# Access Compliance Report

## Public Rights-of-Way

### (Curb Ramps)

Intersection ID: 28728	Main Street: ABSON_CT	Cross Street: STEWARTS_CROSSING_DR	Location: N
ADA ID: 88CE1F47F59A	Ramp Type: BlendTrans1	Initial Pass/Fail: Fail	Overall Compliance: No
Severity Score: 21.25			
Codes/Mitigation Info/Possible Solution		Field Measurements/Component Compliance

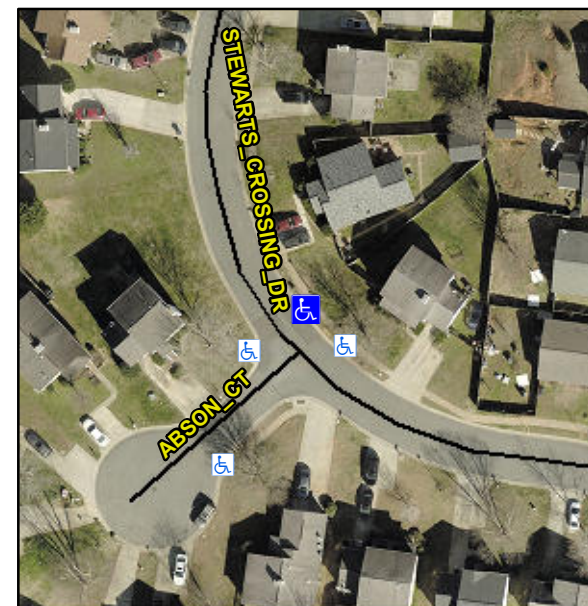
**Not Found, R304.5.1, R304.5.3**

Compliance	Description	Data	Compliance	Description	Data
N/A	Ramp Length (in)	38.5	Yes	BlendTrans Slope (%)	3.7
No	Ramp Width (in)	46.5	No	BlendTrans XSlope (%)	5.5
N/A	Flare Type LT	N/A	N/A	Flare Type RT	N/A
N/A	Flare Slope LT (%)	N/A	N/A	Flare Slope RT (%)	N/A
N/A	Flare Traversable LT?	N/A	N/A	Flare Traversable RT?	N/A
N/A	Landing Length (in)	N/A	N/A	DWS Provided?	N/A
N/A	Landing Width (in)	N/A	N/A	DWS Contrast?	N/A
N/A	Landing Slope (%)	N/A	N/A	DWS Length (in)	N/A
N/A	Landing X Slope (%)	N/A	N/A	DWS Full Width?	N/A
N/A	Landing Curb? (Y/N)	N/A	N/A	DWS Offset (in)	N/A
N/A	Shared Landing?	N/A			
N/A	Gutter Ponding?	N/A	N/A	Gutter Slope (%)	N/A
N/A	Gutter Lip Ht (in)	N/A	N/A	Gutter X Slope (%)	N/A
N/A	Painted X Walk1?	No	N/A	Painted X Walk2?	N/A
	X Walk 1 Direction	To SW		X Walk 2 Direction	N/A
	X Walk 1 Width (in)	N/A		X Walk 2 Width (in)	N/A
	X Walk 1 Slope (%)	2.2		X Walk 2 Slope (%)	N/A
	X Walk 1 X Slope (%)	4.0		X Walk 2 X Slope (%)	N/A

N/A	Ramp inside XWalk1?	N/A	N/A	Ramp inside XWalk2?	N/A
	Road Slope (%)	4.0		Clear Space?	N/A
	Road X Slope (%)	2.2	N/A	Clear Space to XWalk (in)	N/A
N/A	Any Obstructions?	N/A	N/A	Storm Grate/Utility Hazard?	N/A
	Obstruction Type			Storm Grate/Utility Type	
		N/A			N/A
			Yes	Surface Condition? (G/P)	Good
			No	Curb Slope (%)	15.4

**Remove & Replace Curb Ramp With Two New Directional Ramps or Equivalent.**
